STAG BREWERY MORTLAKE LANDSCAPE DESIGN - PLANNING ADDENDUM

REV00 JULY 2022

This landscape Design and Access Statement addendum was prepared by Gillespies Landscape Architects, on behalf of Reselton Properties Limited, to respond to recommendations and comments received as part of the consultation period for the two submitted linked planning applications (March 2022) for the comprehensive redevelopment of the former Stag Brewery Site in Mortlake, within the London Borough of Richmond upon Thames. Application A (ref: 22/0900/OUT) for the masterplan redevelopment and Application B (ref: 22/0902/FUL) for the school.

The following document includes updated information that superseeds the corresponding information submitted as part of the Landscape Design and Access Statement (March 2022). A comprehensive summary of changes is provided on each page.

LANDSCAPE MASTERPLAN

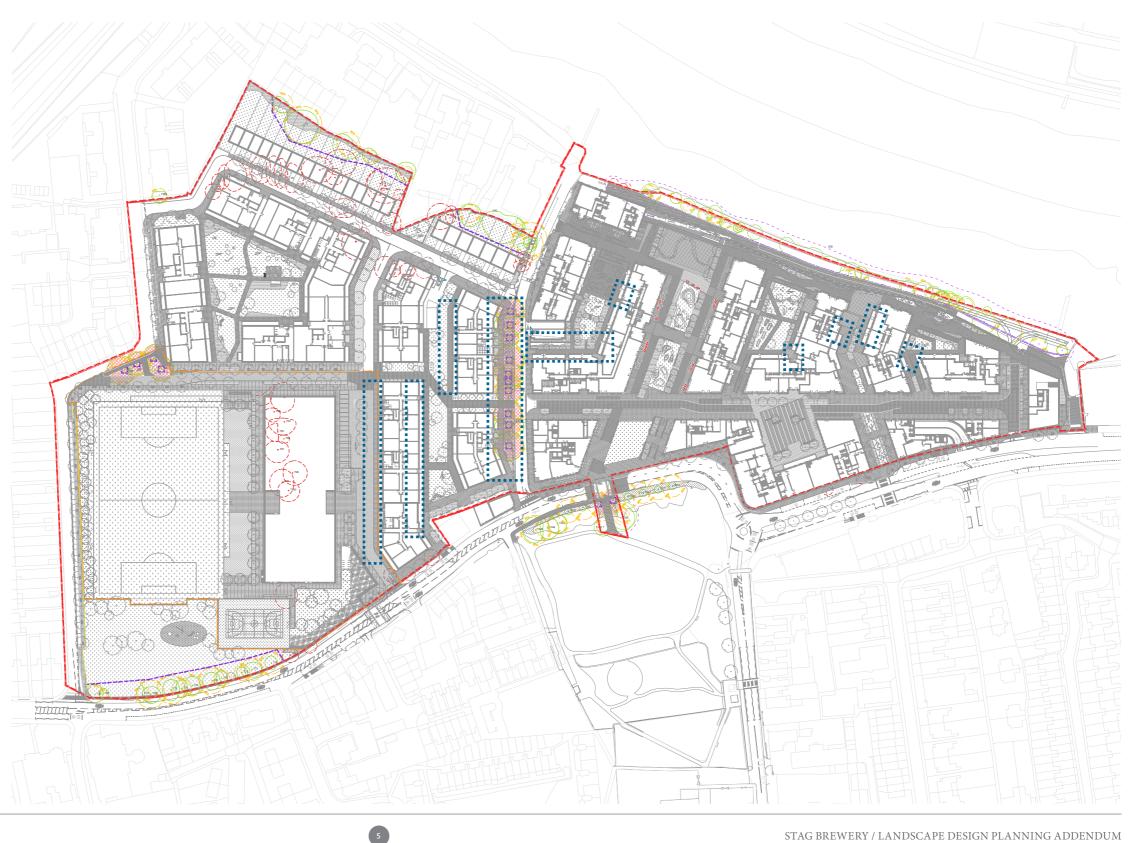
Changes to the landscape masterplan were informed by comments received during the determination of the application, which include:

- Introduction of seperate entrances to the building basements and of refuse stores at ground floor level on Blocks 2,7,8,11,13,15 and 17. (*HSE Gateway 1 Substantive response May 2022 p.3, para(s)1.8*)

- Adjustment to private terraces and introduction of more amenity planting (A), site wide, as a result of the introduction of new entrances to the buildings.

- Relocation of the pedestrian ramp between Blocks 2 and 3, due to the introduction of a new entrance to the north facade of Block 2. (B)
- Relocation of play area and cycle stands within pocket park, due to introduction of private terraces to the east facade of Block 17. (C)

- Adjustements to the lighting design strategy and to the location of luminaires site wide, to avoid clashes with trees hence avoiding maintenance issues. (*Consultee responses May 2022*, *p.12*, *Trees/Further Detail required/'e'*)

- Improvements to lighting and landscaping (addition of benches) at Maltings Plaza (D) (Consultee responses May 2022, p.2, Landscape Masterplan/DAS/ 's' and Lighting Masterplan/ 'u')

Drawings P10736-00-004-GIL-0100 to 104, 106,107, 116, 120,122,123,140 and 150 were amended to reflect these changes.

CIRCULATION AND ACCESS

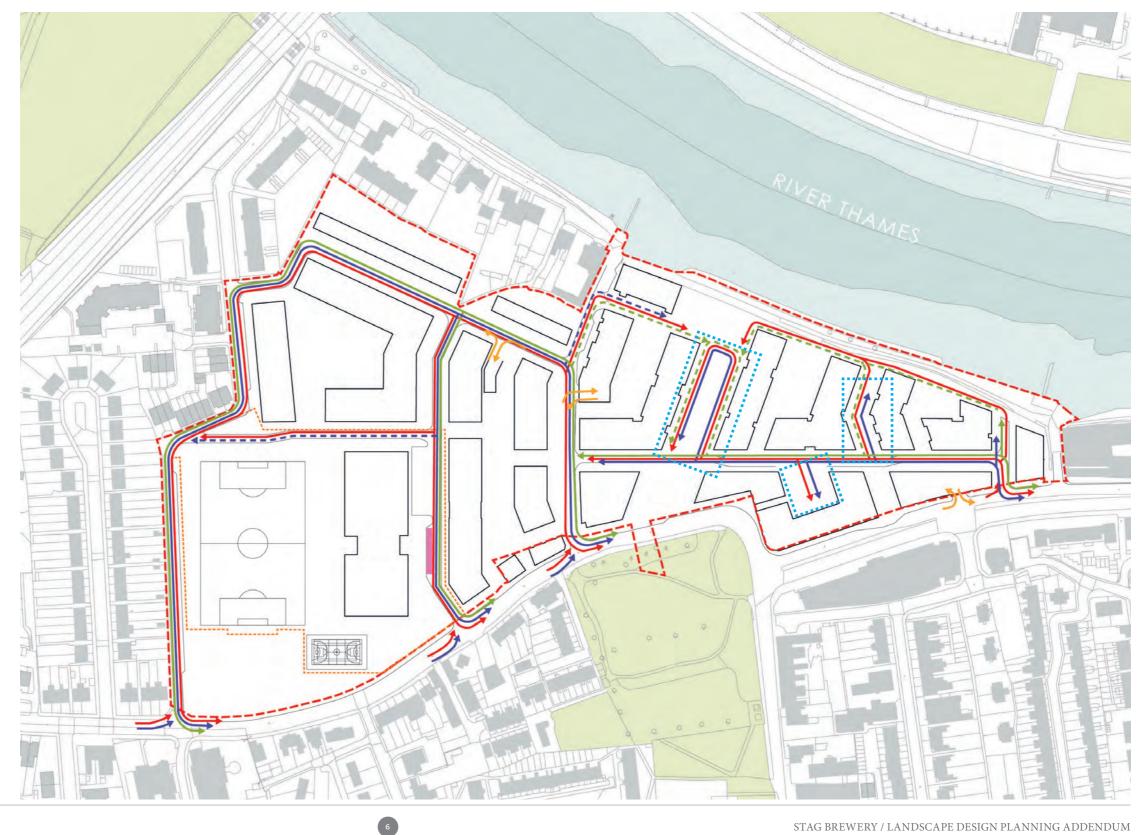
The refuse vehicle circulation network was expanded due to the introduction of refuse stores at ground level on Blocks 2,7,8,11,13,15 and 17

Drawings P10736-00-004-GIL-0107 was updated to reflect these changes.

CIRCULATION AND ACCESS

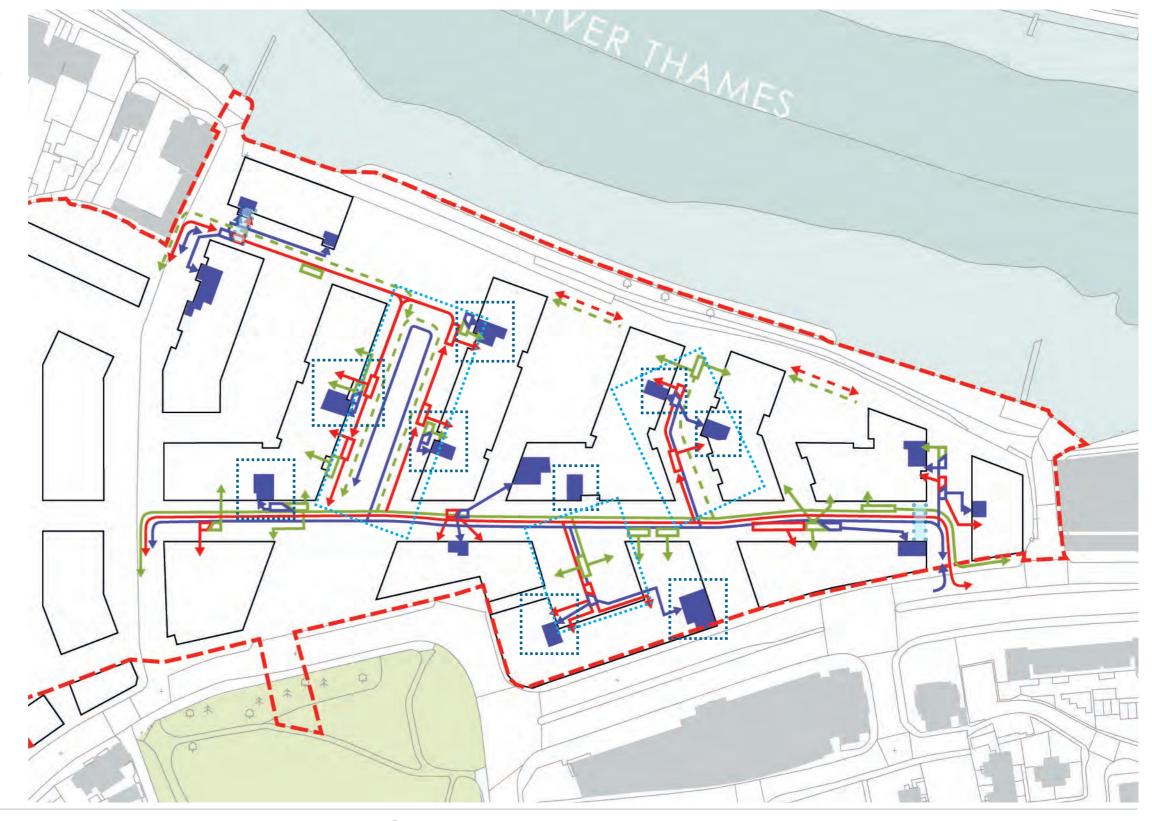
The refuse store network on Development Area 1 was expanded due to the introduction of refuse stores at ground level on Blocks 2,6,7,8 and 11.

Drawings P10736-00-004-GIL-0101, 103, 106, 107 and 116 were updated to reflect these changes.

HARD LANDSCAPE STRATEGY

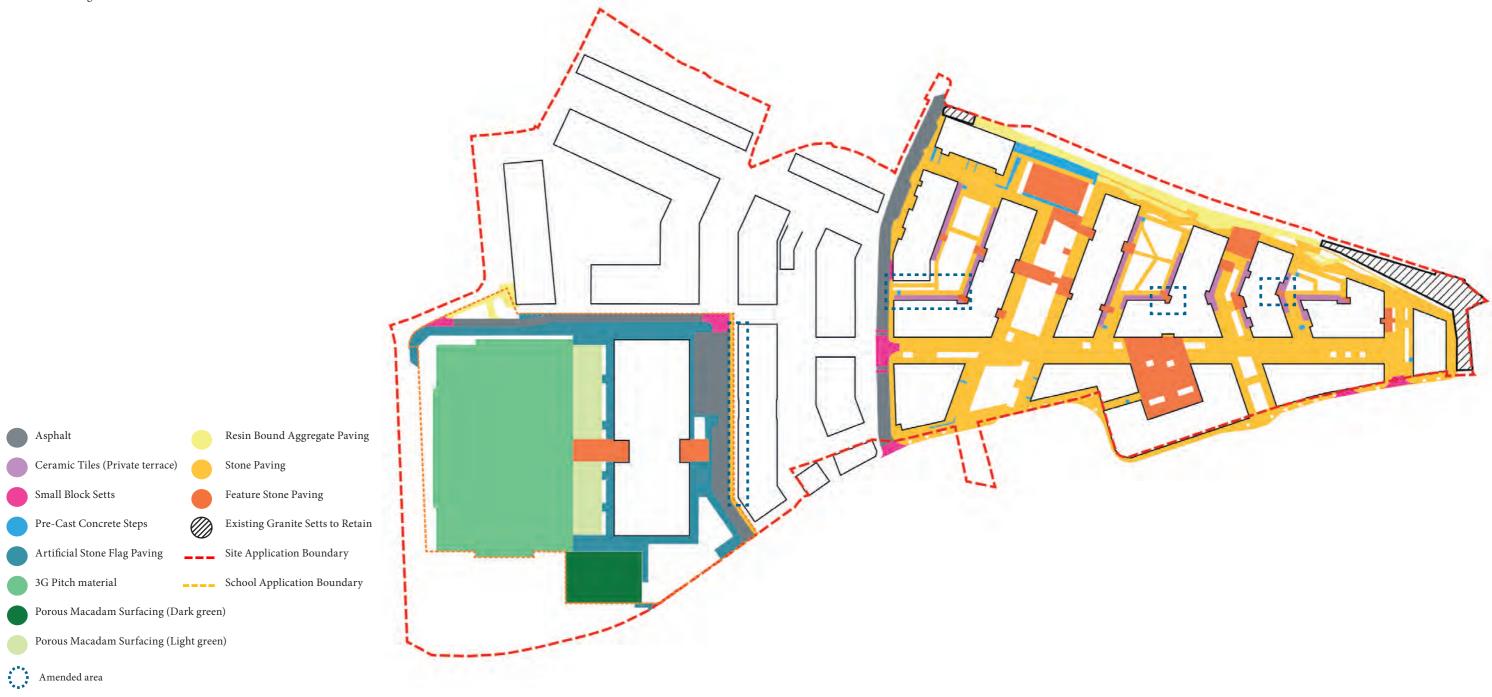
Minor amendments were made to the extents of hardscape due to the introduction of entrances and the adjustment of layouts of private terraces.

Drawings P10736-00-004-GIL-0100 to 103, 106, 116 and 140 were updated to reflect these changes.

FURNITURE STRATEGY

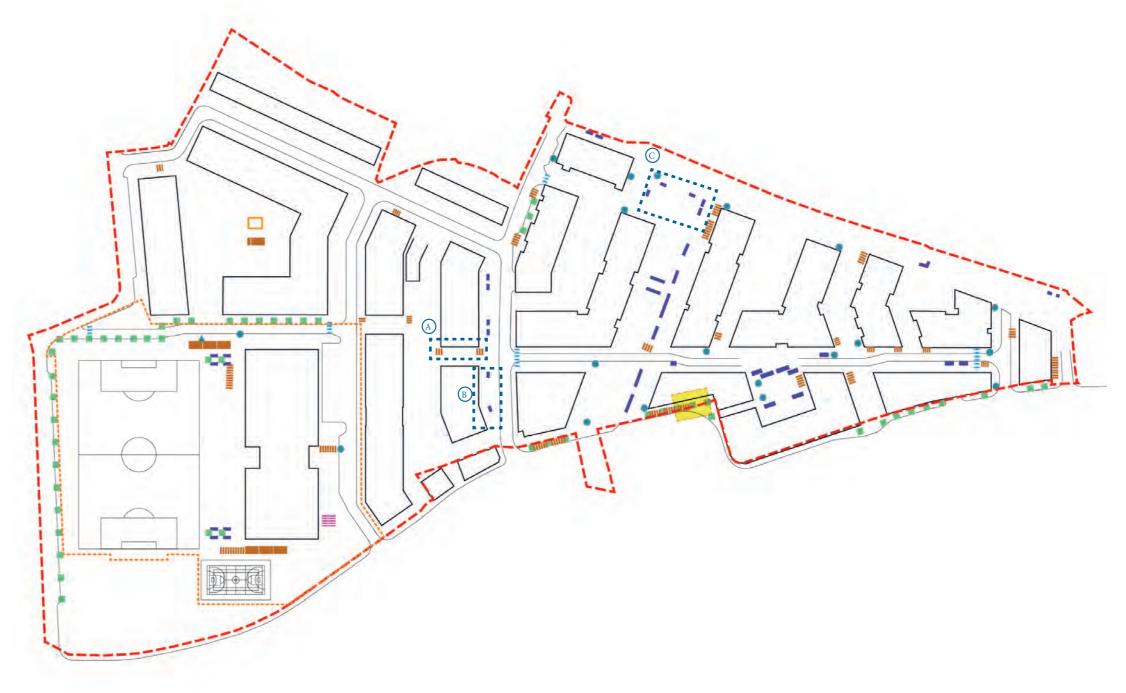
The location of the cycle stands (A) was amended and 2 benches (B) were introduced to each side of the relocated play area to the south of the pocket park. Benches (No.5) were also added at Maltings Plaza (C). This brings the total number of benches to 31 - up from 25 at the Submitted Scheme.

Drawings P10736-00-004-GIL-0100 to 104, 122 and 140 were updated to reflect these changes.

CYCLE PARKING STRATEGY

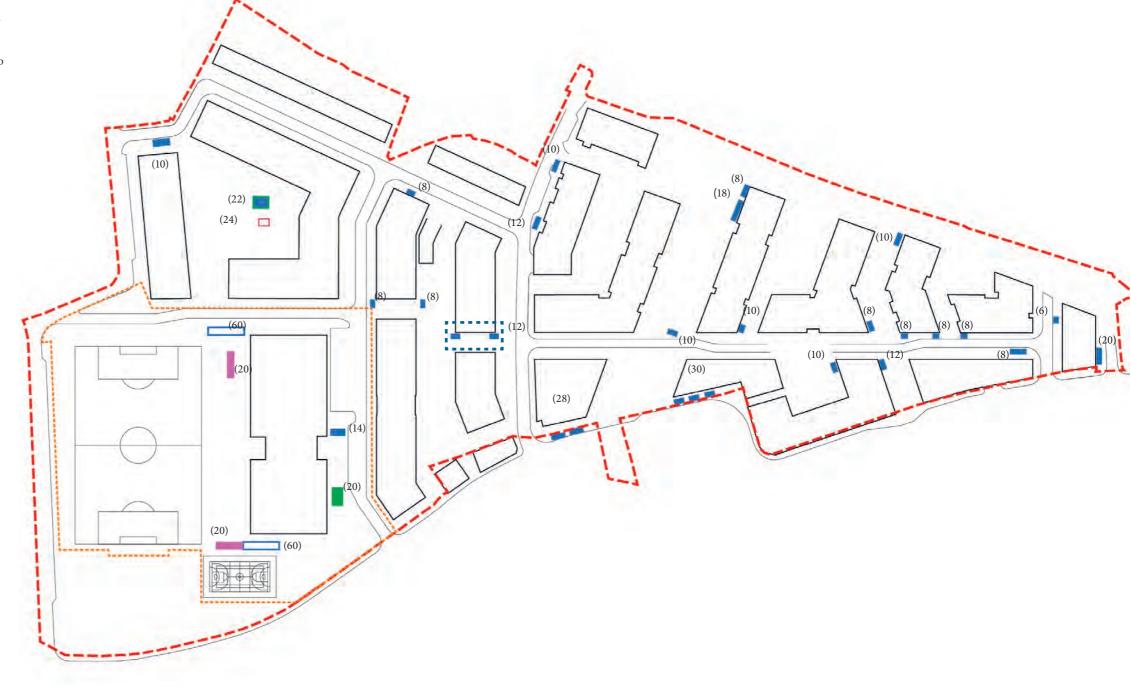
The cycle stands are relocated on the pedestrian street adjacent to the pocket park due to the introduction of private terraces along the east facade of Block 17.

Drawings P10736-00-004-GIL-0100 to 103, 120, 122, and 140 were updated to reflect this change.

PLAY STRATEGY

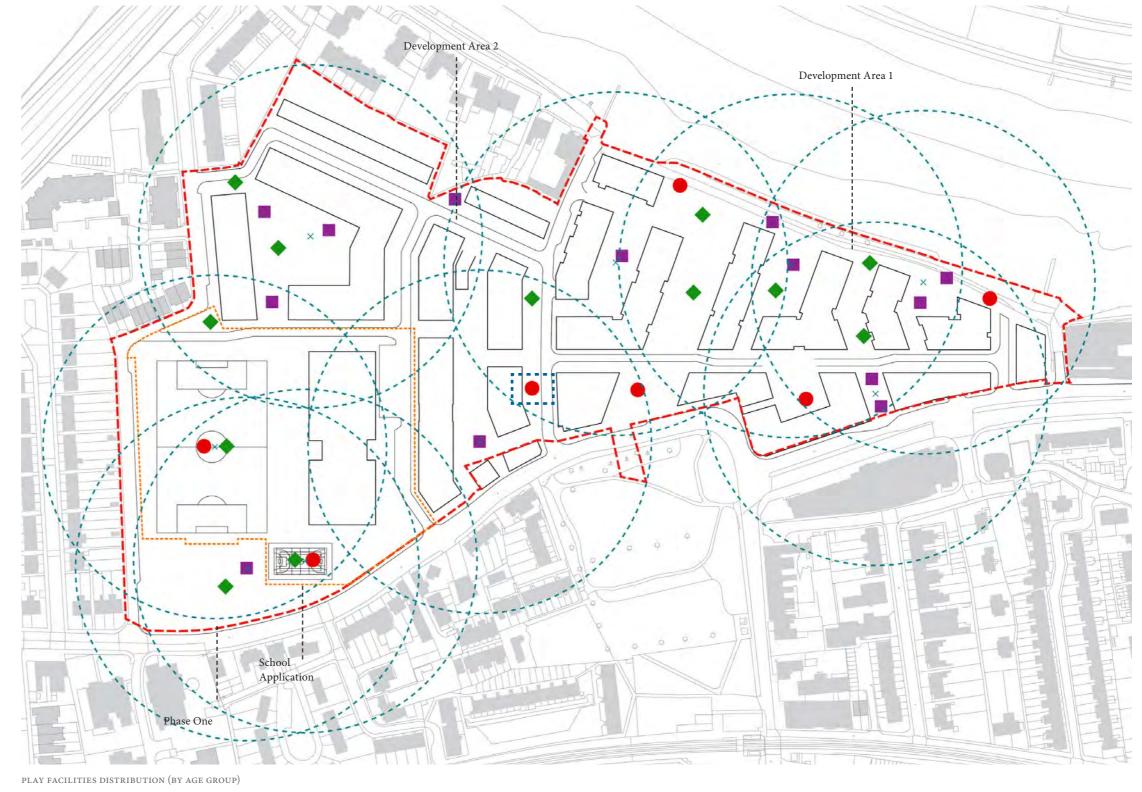
The play are for the 12+ age group was relocated to the south of the pocket park due to the introduction of private terraces at the east facade of Block 17.

Drawings P10736-00-004-GIL-0100 to 104, 120, 122, 123, 140, and 208 were updated to reflect this change.

PLAY STRATEGY - SITE-WIDE APPROACH

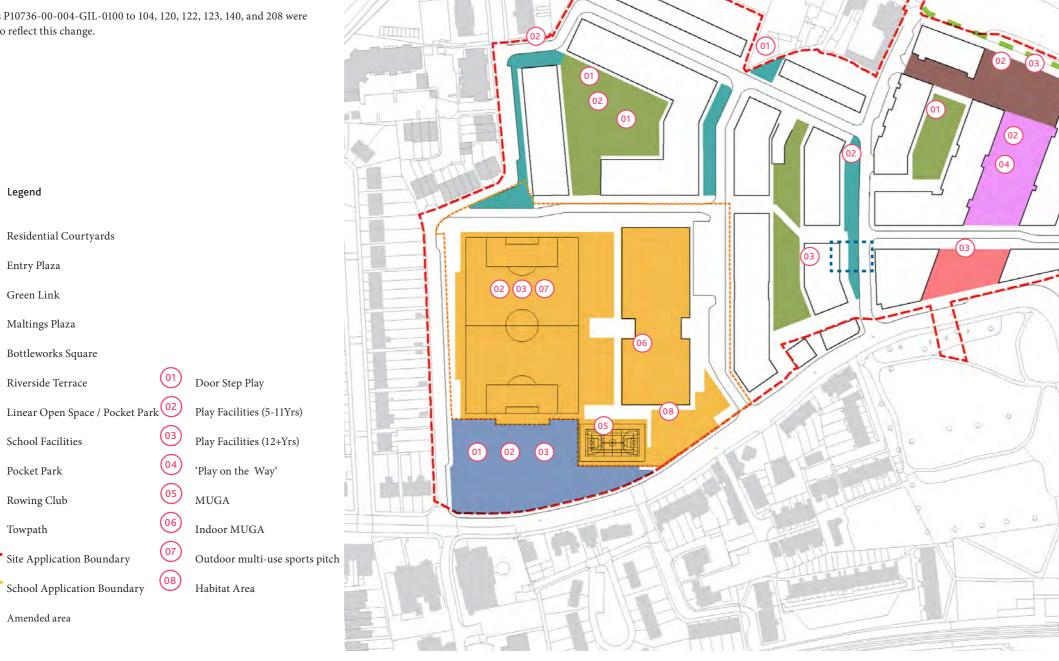
The play space for the 12+ age group moved to the south of for the pocket park along Ship Lane.

Drawings P10736-00-004-GIL-0100 to 104, 120, 122, 123, 140, and 208 were updated to reflect this change.

MALTINGS PLAZA LOOKING SOUTH - ILLUSTRATIVE VIEW

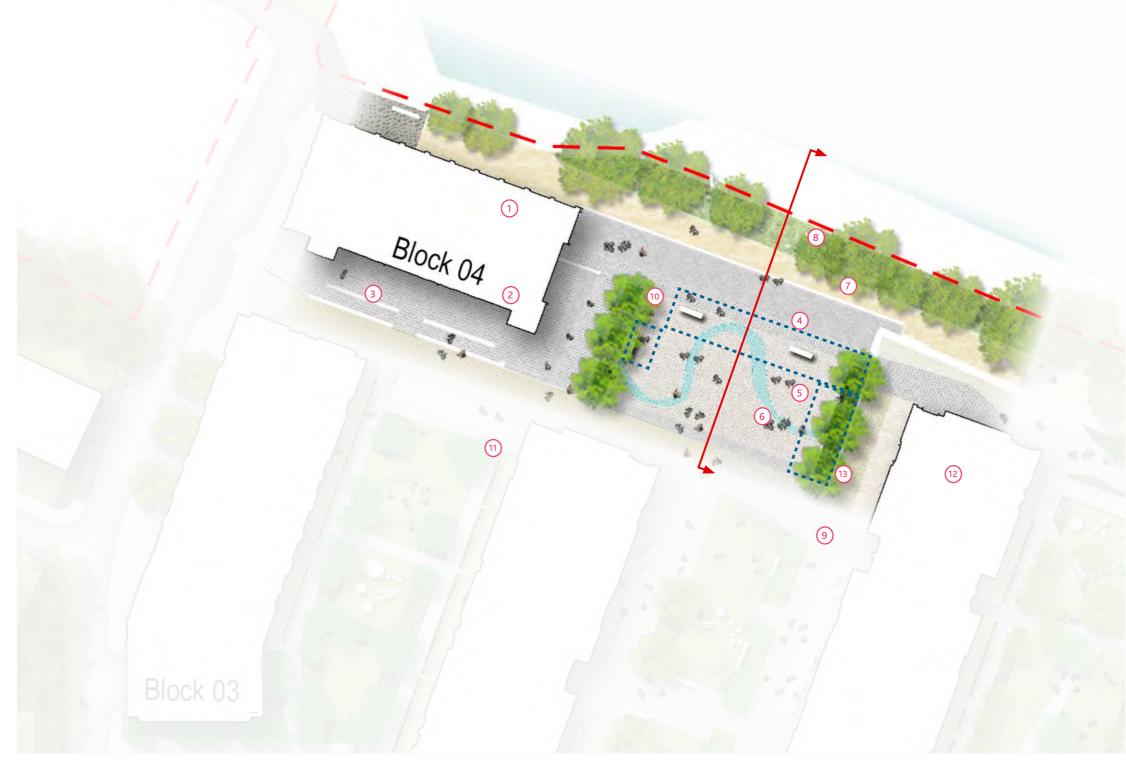
The view was updated as a response to the Consultee responses received in May 2022, (p.2, Landscape Masterplan/DAS/ 's').

The updated Maltings Plaza view shows the desired height of the planting, extra benches on the plaza itself and lighting columns that are both functional and discreet, responding to their sensitive location next to the historic Maltings building.

MALTINGS PLAZA - SECTION

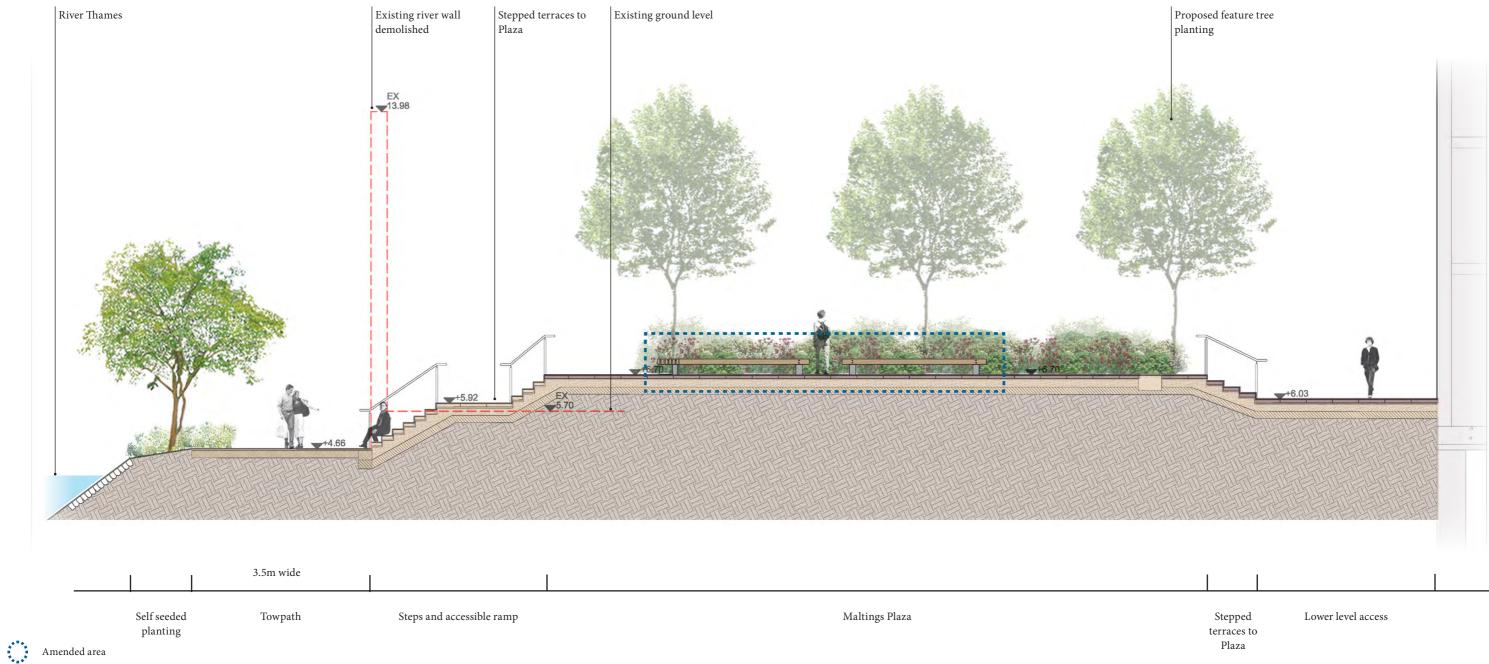
The plan was updated as a response to the Consultee responses received in May 2022, (p.2, Landscape Masterplan/DAS/ 's'), and benches were added in 4 locations.

Drawing P10736-00-004-GIL-0205 was updated to reflect this change.

SHIP LANE NORTH - SECTION

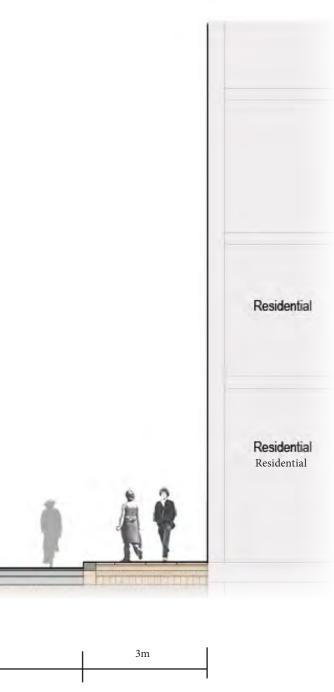
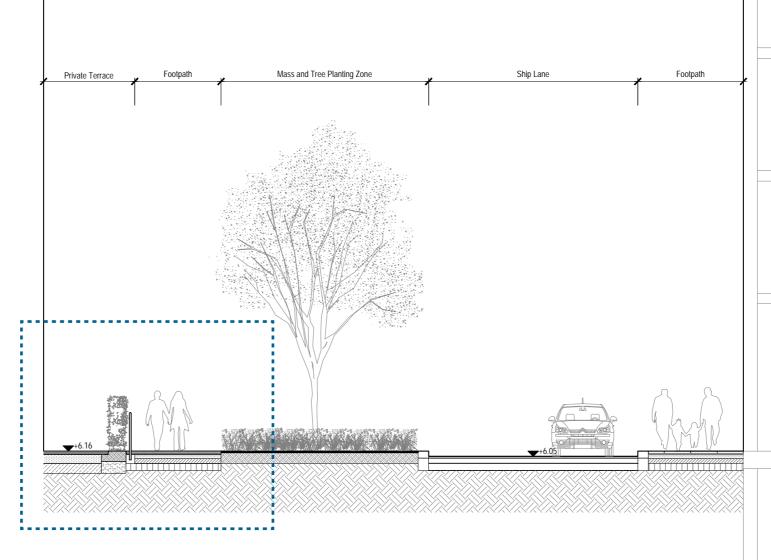
The introduction of private terraces along the east facade of Block 17 meant the slight reduction of the green area of the pocket park and the addition of hegding and amenity planting immdiately adjacent to Blcok 17.

Drawings P10736-00-004-GIL-0208 was updated to reflect this change.
